File Ref: 21/117
 30 June 2022

Subject: Moss Vale Road North URA – Draft DCP
Lot 7 DP 618693 Bells Lane Meroo Meadow

On behalf our client, HDB are submitting the following submission in response to the Moss Vale Road North URA – Draft DCP.

Figure B: Recommended Collector Road Profile

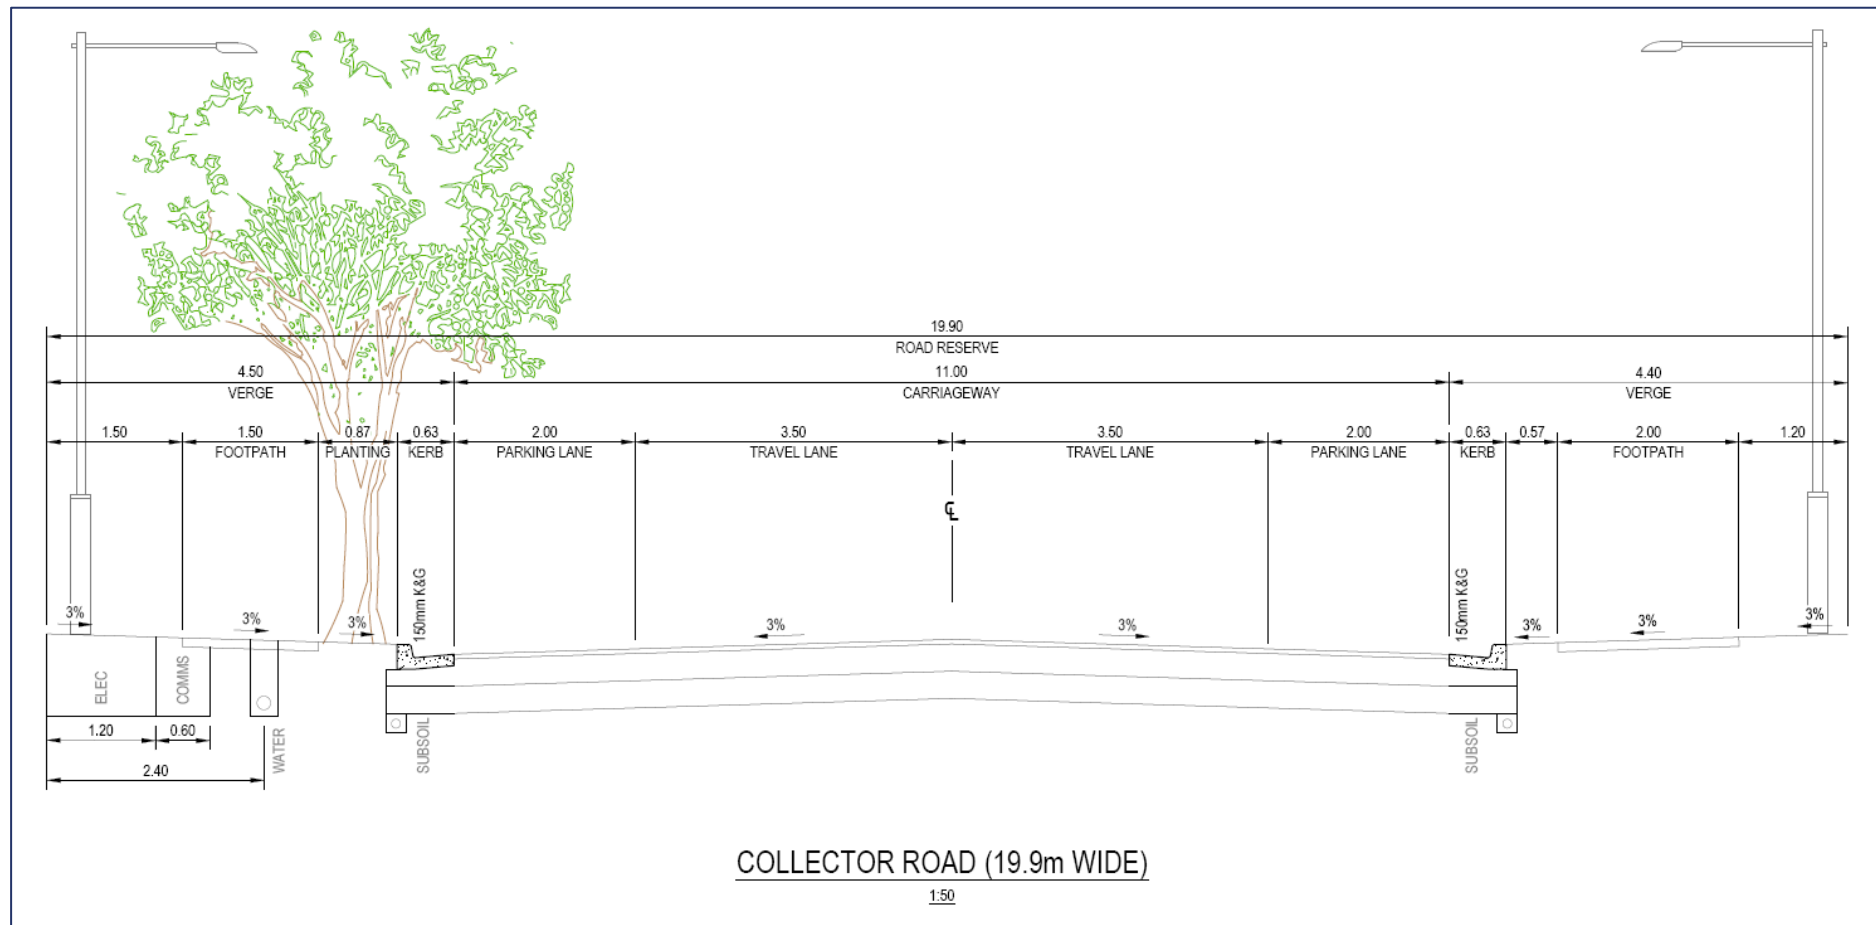
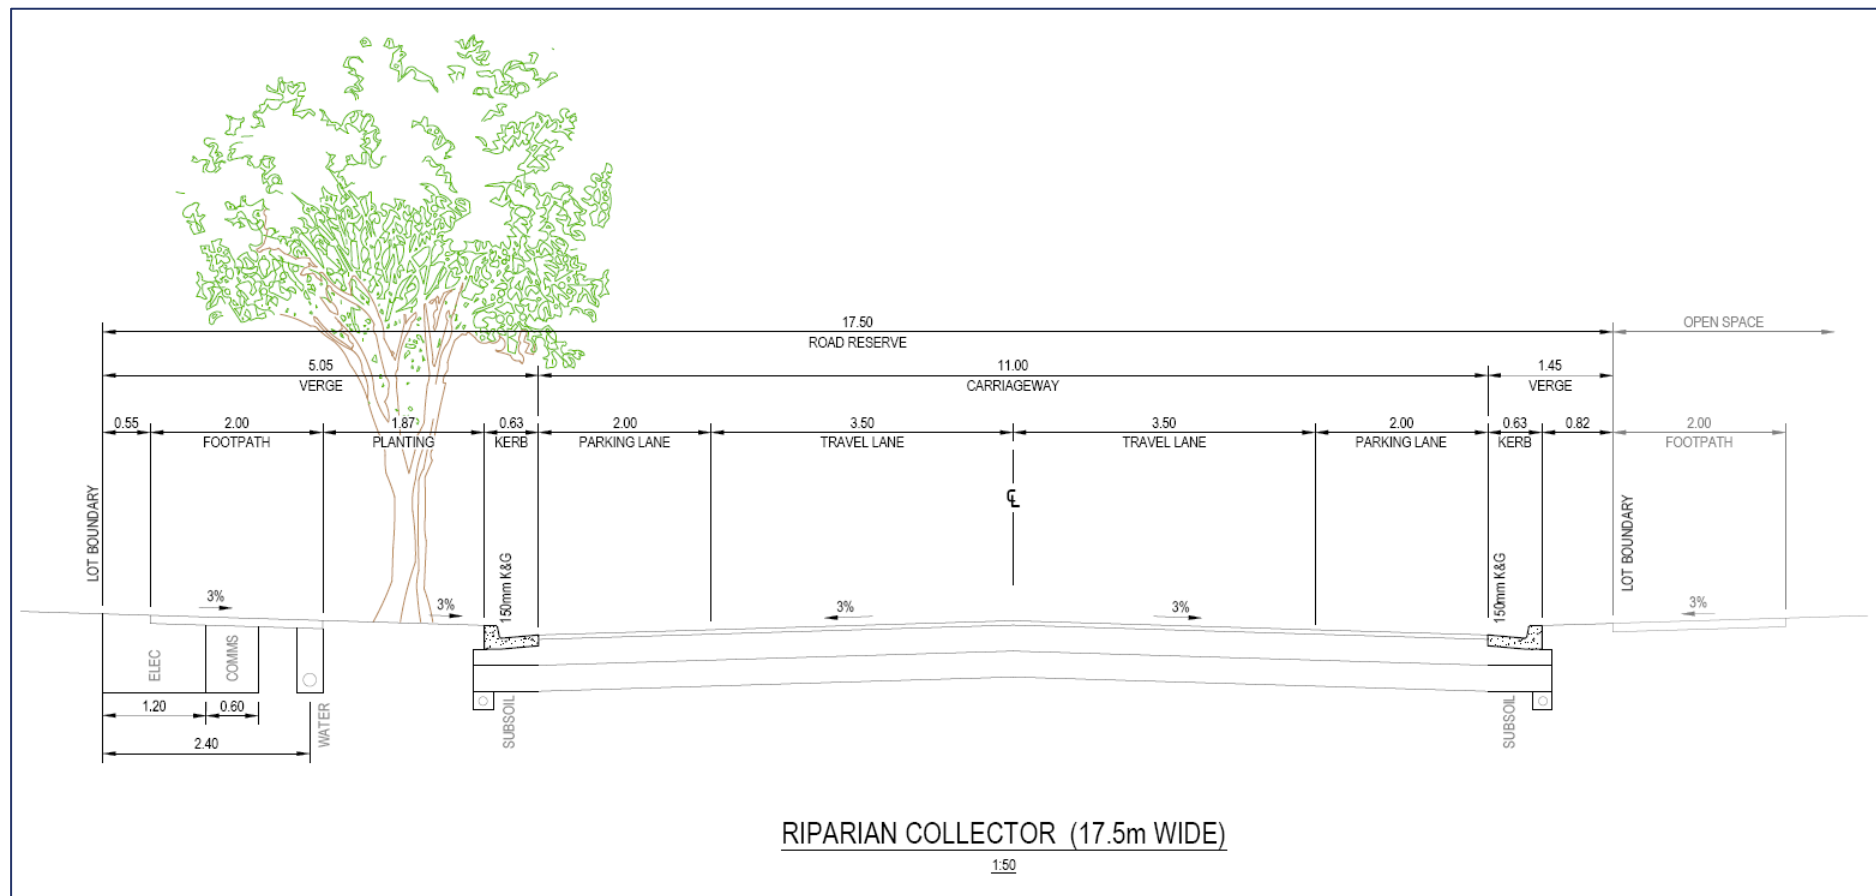
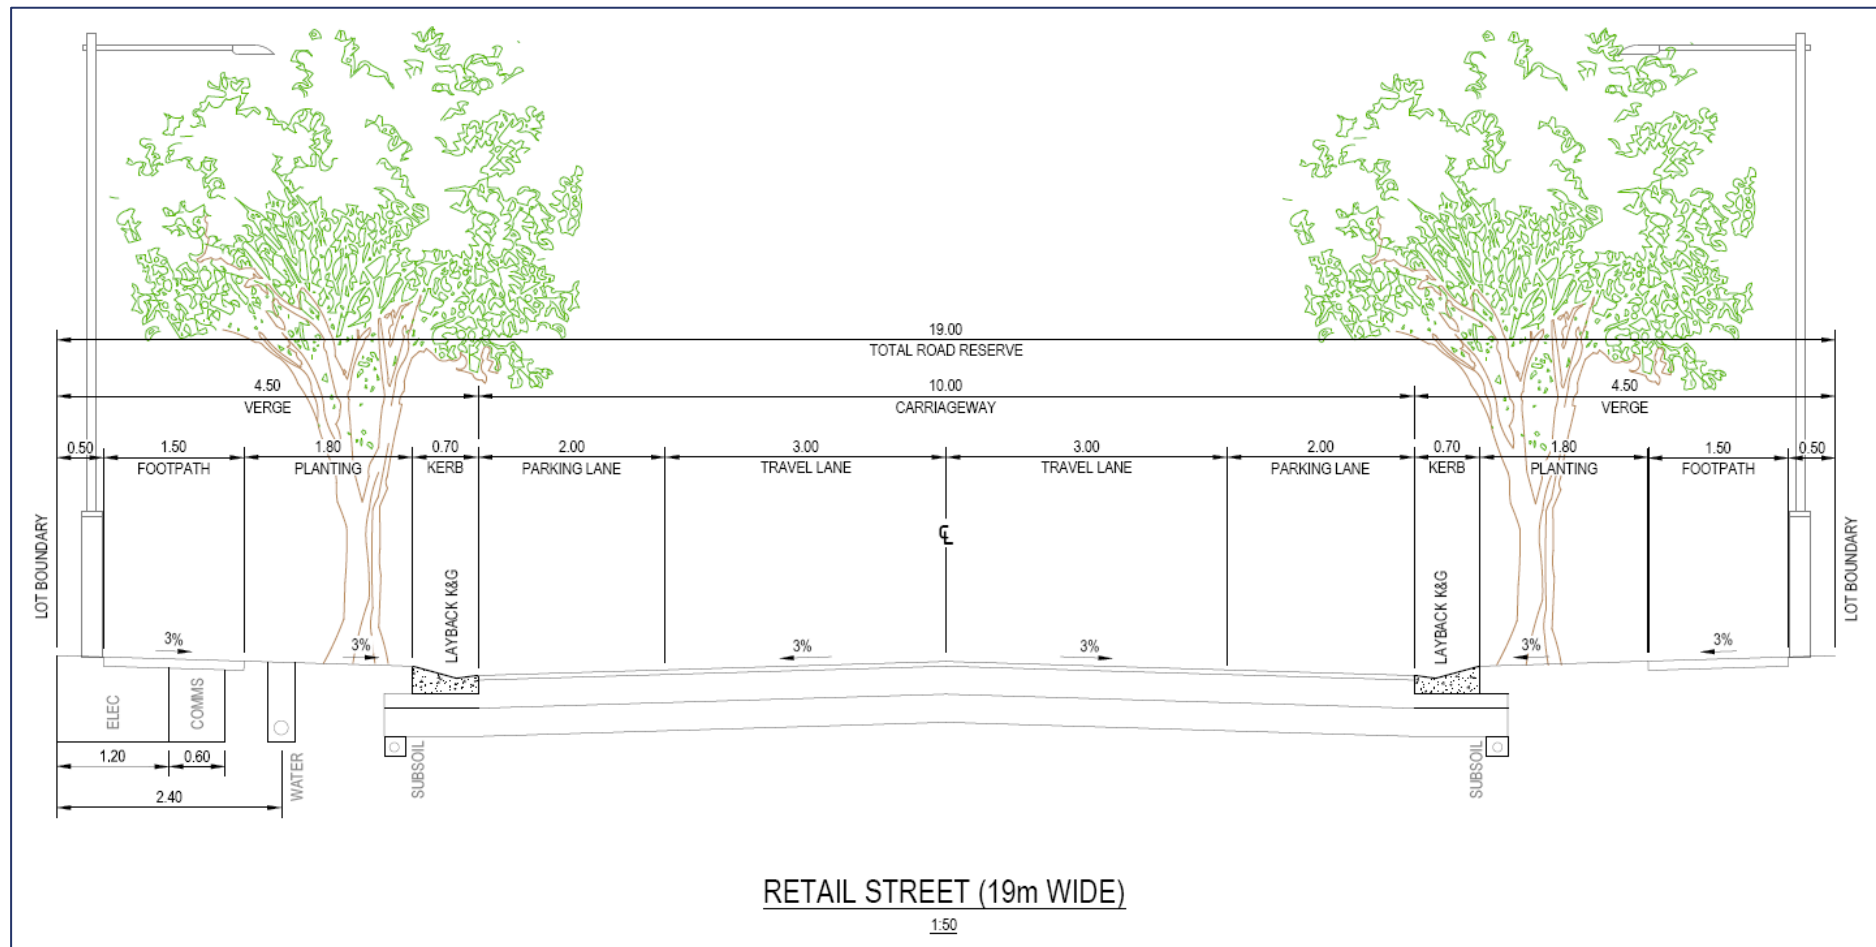
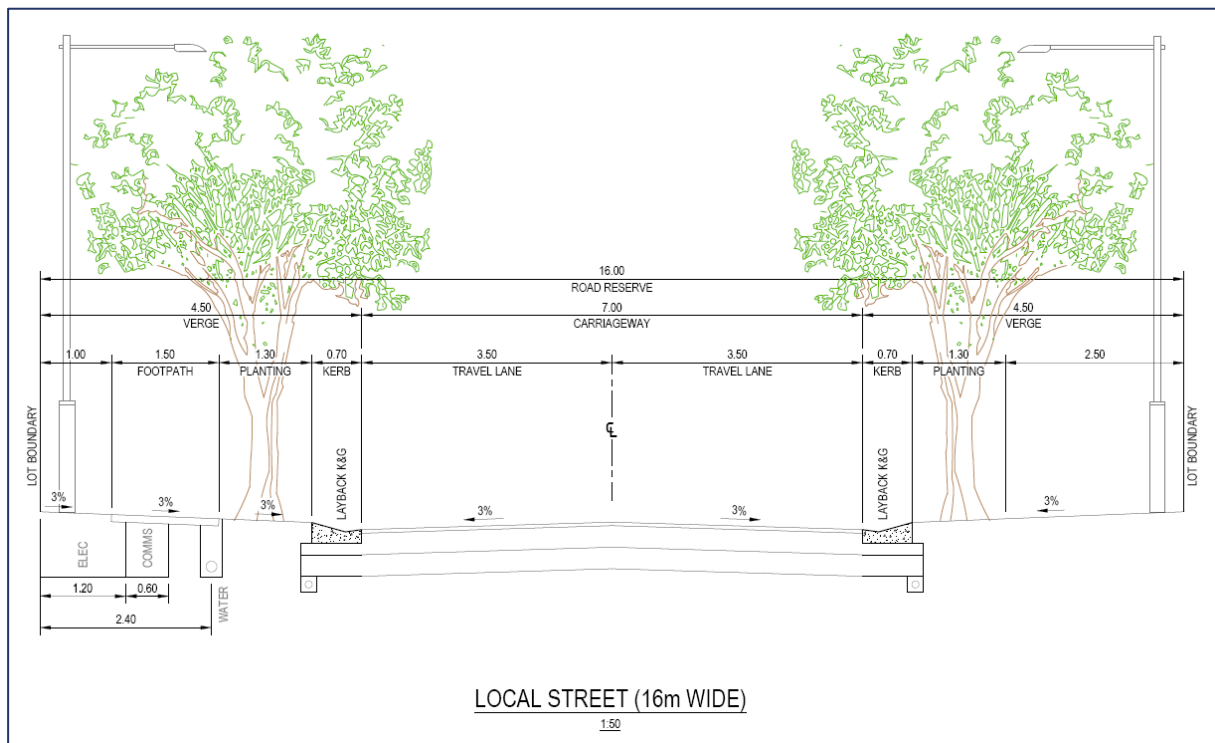
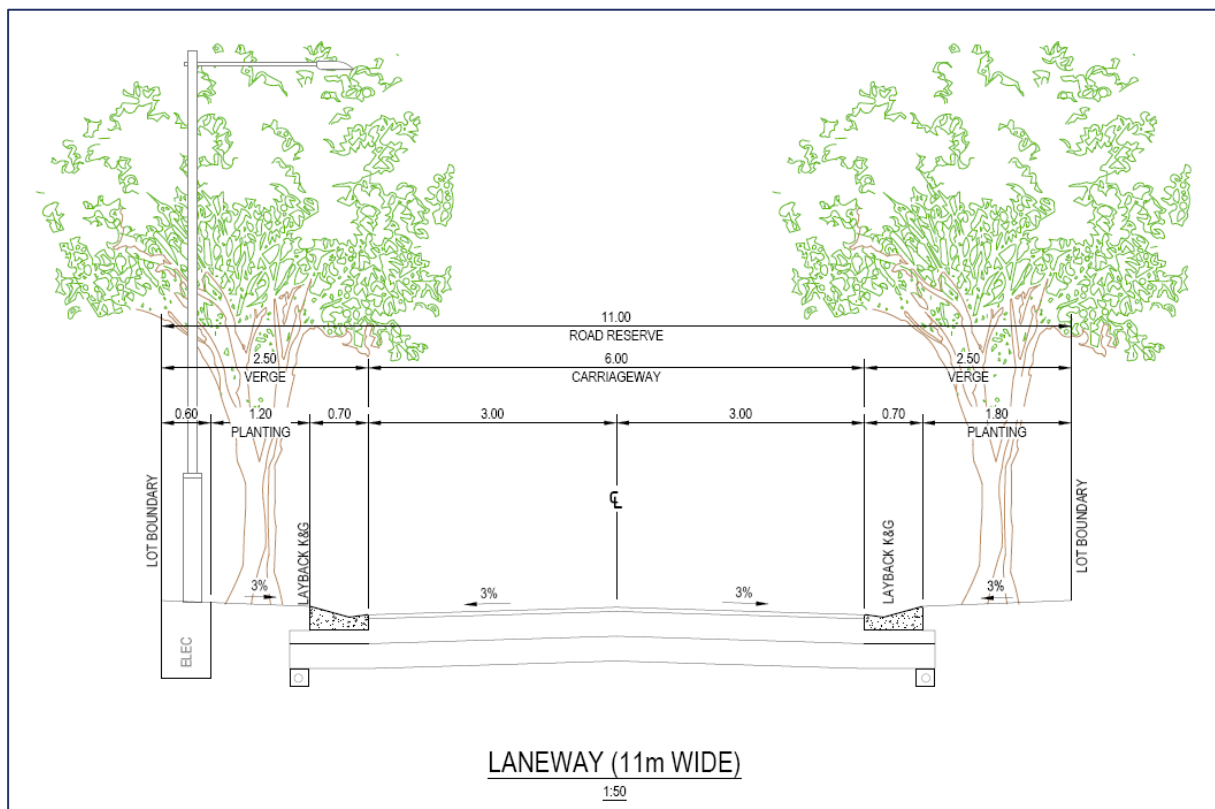
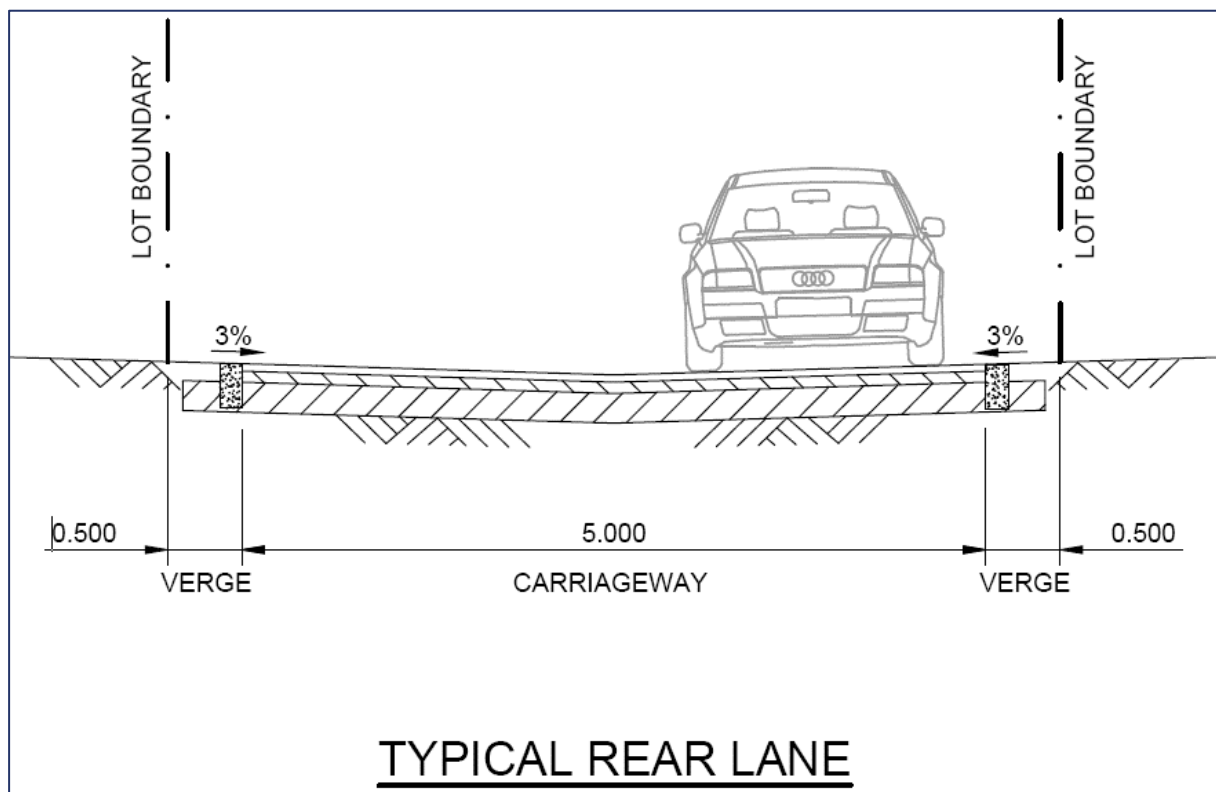
Further to the above, **arc traffic + transport** recommends that the road profiles shown in Section 7.4 of the MVRN Draft DCP be revised to include the road profiles adopted in the Concept Plans, the characteristics of which are summarised in **Table A** and figures below.

Figure I: Recommended Street Hierarch & Network Plan

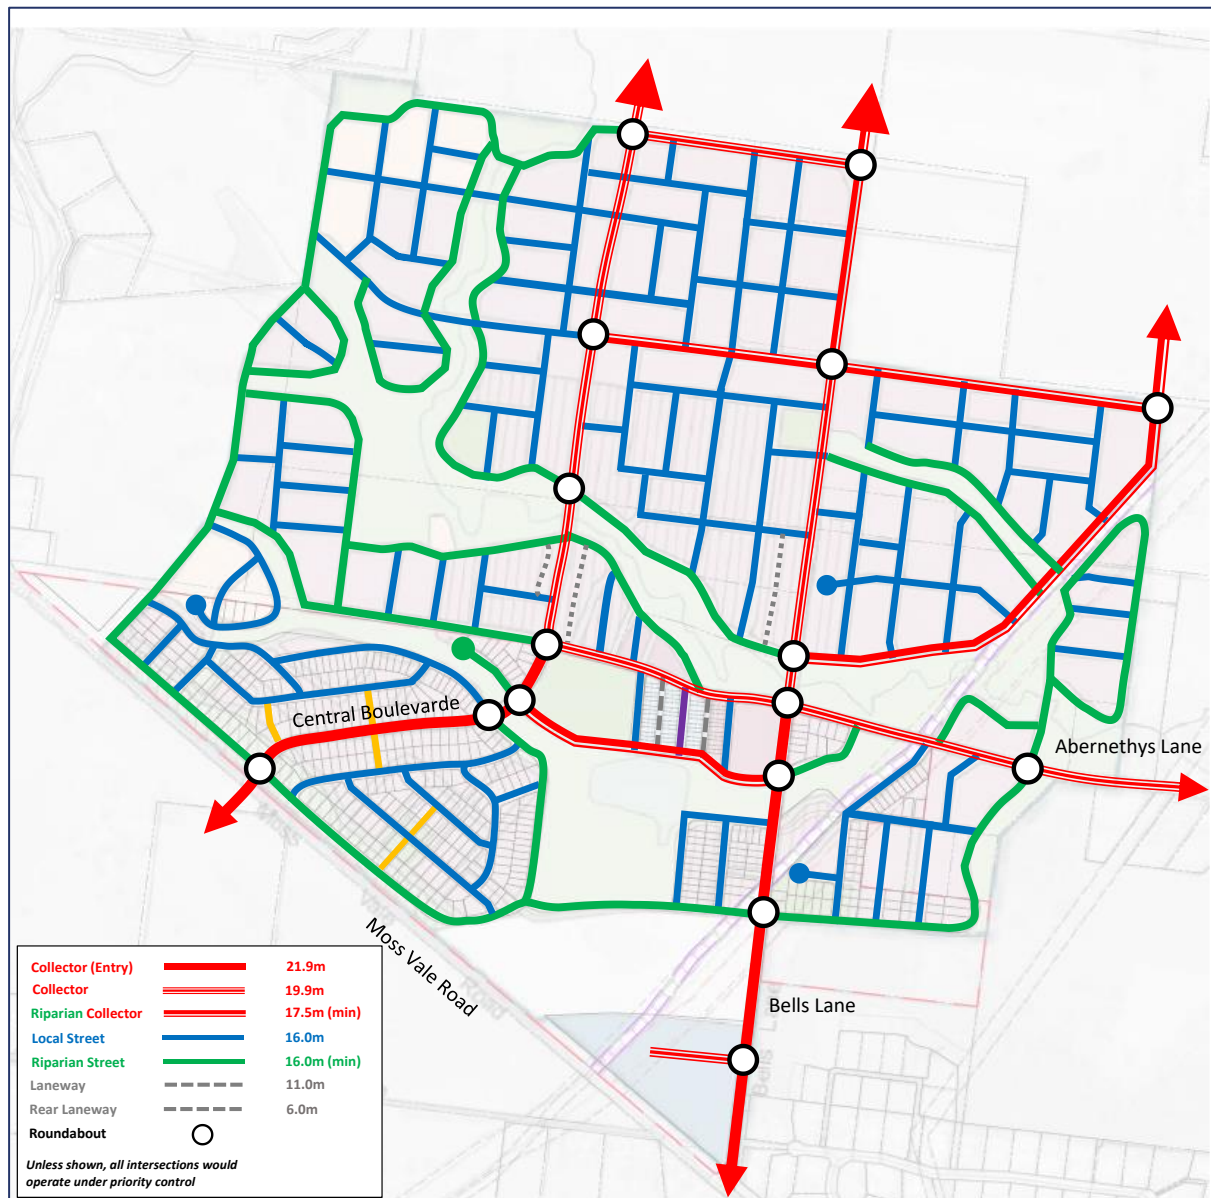
Further to our detailed assessment of the traffic and access characteristics of the MVRN URA, [arc traffic + transport](#) recommends that the *Street Hierarchy and Network Plan* provided as Figure 7 of the MVRN Draft DCP be revised in accordance with the Figure I below.

Finally, it is acknowledged that there may be additional changes to the Concept Plans further to ongoing planning and design development by the individual Proponents (and other developers in the MVRN URA); however, these changes are not anticipated to significantly alter the identified structure of the Collector Road or Perimeter Road network.

Figure 4: MVRN Draft DCP Street Hierarchy and Network Plan

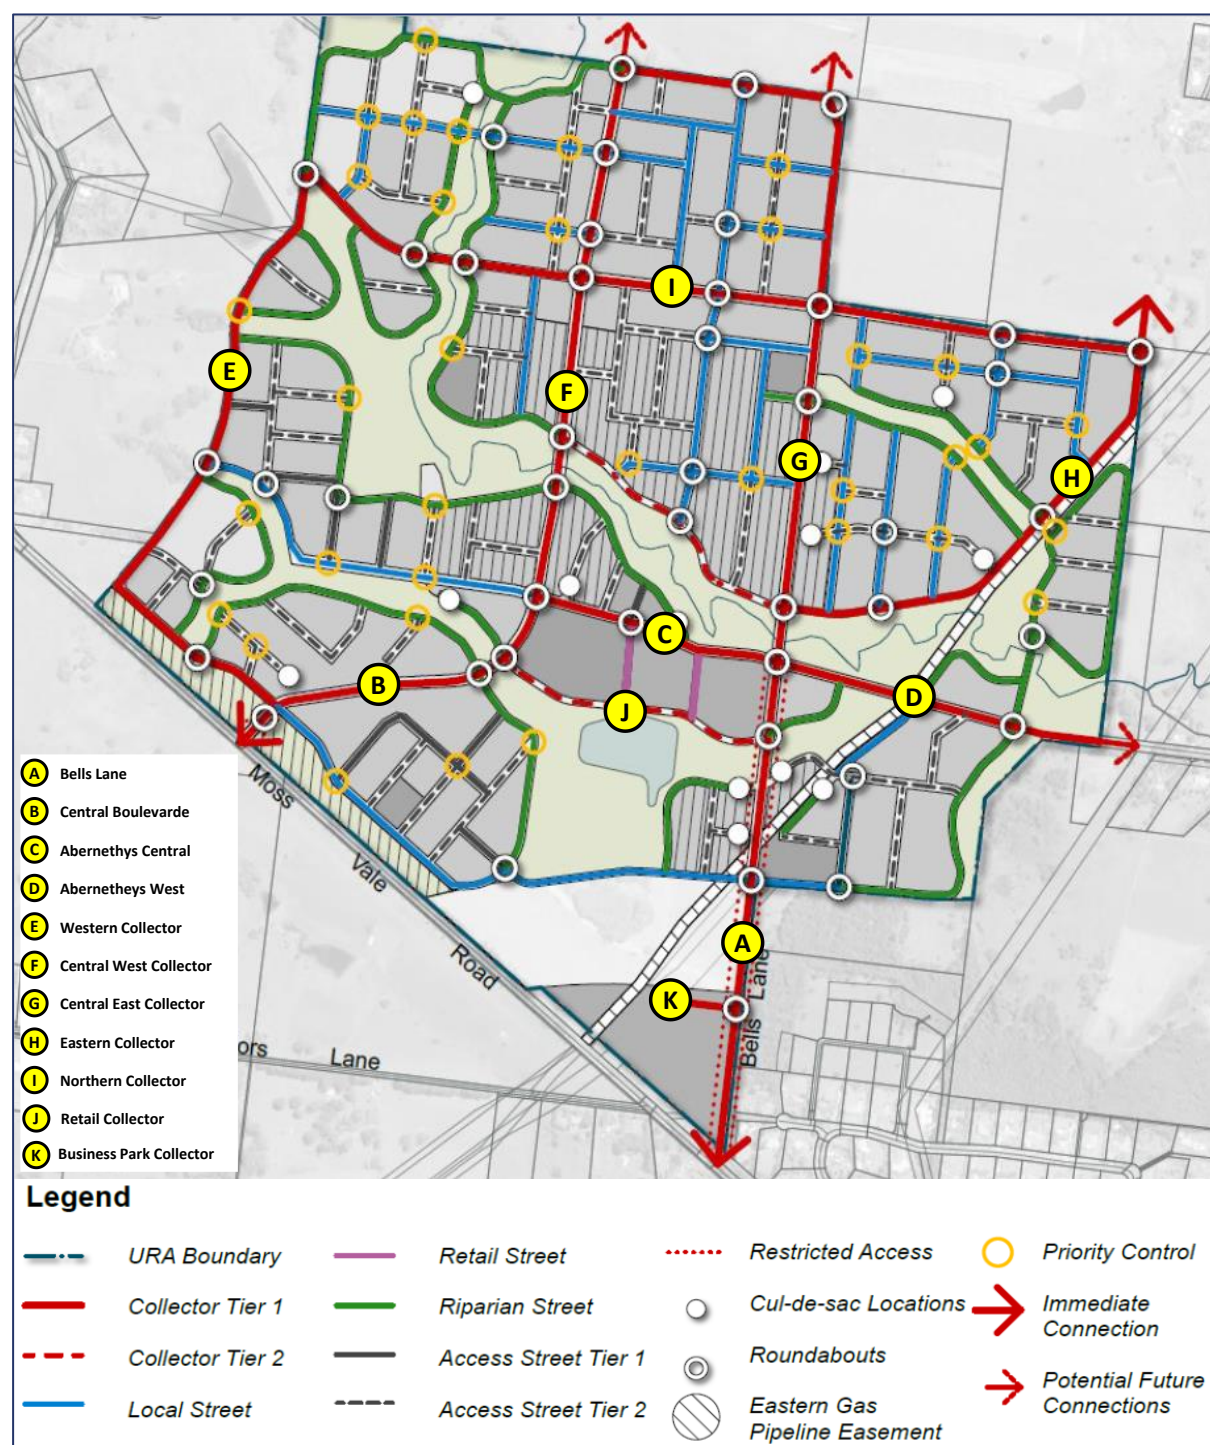
The *Street Hierarchy and Network Plan* for the MVRN URA (**MVRN SHNP**) is provided as Figure 7 of the MVRN Draft DCP, and is reproduced below, noting that **arc traffic + transport** has named a number of key roads for ease of reference in later sections of this Transport Assessment.
